December 16, 2008
Final Draft Report
Expedited System Impact Assessment
Hydro One Networks Inc.

**Replacement of Hawthorne R2N; Longwood R4N & R5N
CA ID# 2008-EX410**

Figure 1 – R2N at Hawthorne TS

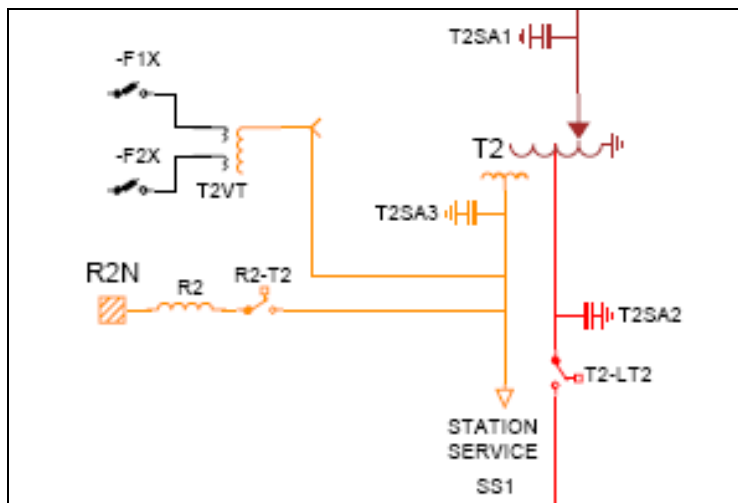
Reactor breakers R2N at Hawthorne TS and R4N and R5N at Longwood TS are being replaced. As shown below in figures 1 and 2, the reactors and breakers are connected to the tertiary winding of the 500/240/28 kV transformers.

The replacement breakers have a higher voltage rating (138 kV vs. 38 kV) than the original breakers.

The maximum voltage rating for the replacement breakers is sufficiently high and therefore, it can be concluded that the replacement breakers will have no material adverse effect on the reliability of the IESO-controlled grid.
